Title - Sujet : Operations Compound Utilities Rehabilitation – Banff National Park	
Solicitation No. - N° de l'invitation : 5P420-20-0092/A	Date : July 20, 2020
Amendment No. - N° de modification : 002	
Client Reference No. - N° de référence du client : 697	
GETS Reference No. N° de reference de SEAG : PW-20-00919430

Amendment 002

This amendment is being raised to distribute questions and answers.

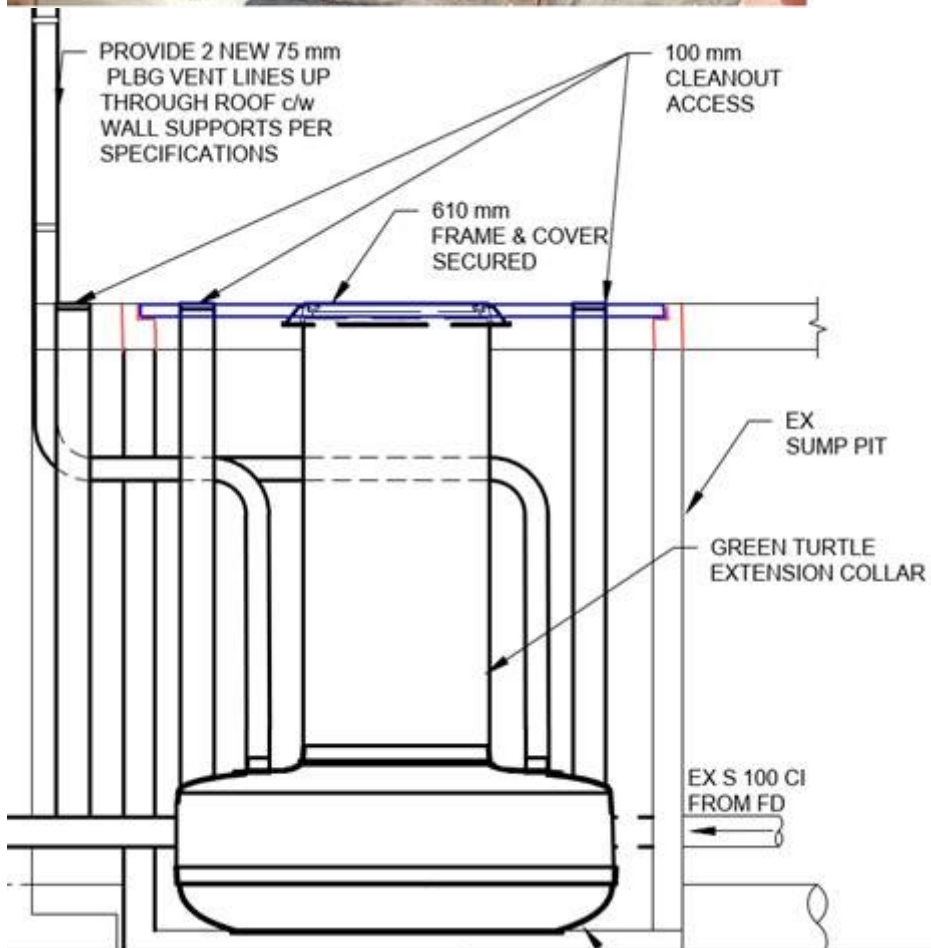
Q15 Is an H20 load rating acceptable for the cover on the Proceptor 50 unit?

A15 The assembly and the lid, as noted on the drawing are to be "AASHTO M306 Traffic Load Rated" as it is located in the mechanic's shop and must have capacity to support heavy vehicles and equipment.
